pSemi Mirafra sync

PE24103 GUI

February 24, 2022

Topics for Discussion

I2C Register Tab

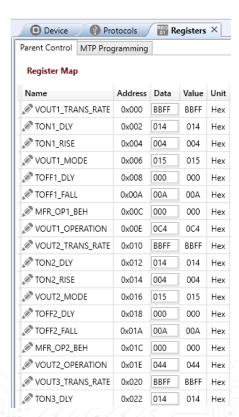
Registers 0x000 thru 0x1FE are Read Only (not controlled by I2C) Suggest that the pencil (write) be removed and changed to book (read), locked (1) or grayed out.

PMBus POWER_GOOD Flag

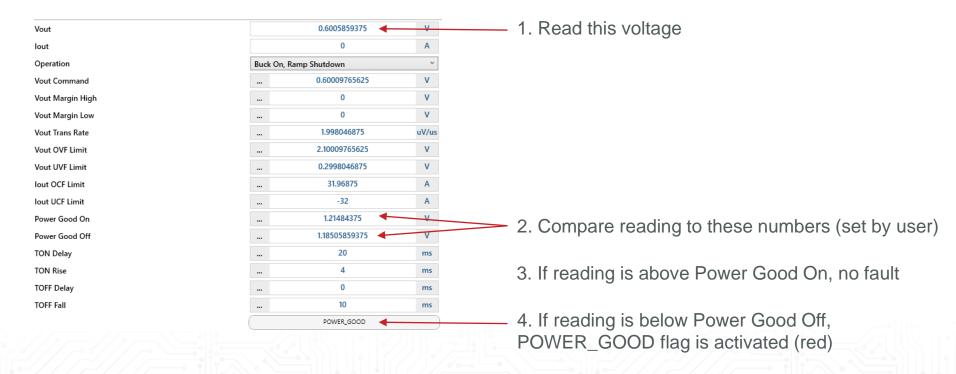
This logic does not appear to work. There should be separate channel control of POWER_GOOD fault.
 Can you verify? (Refer to R2D2_PMBus_IOS_Latest.pdf document)
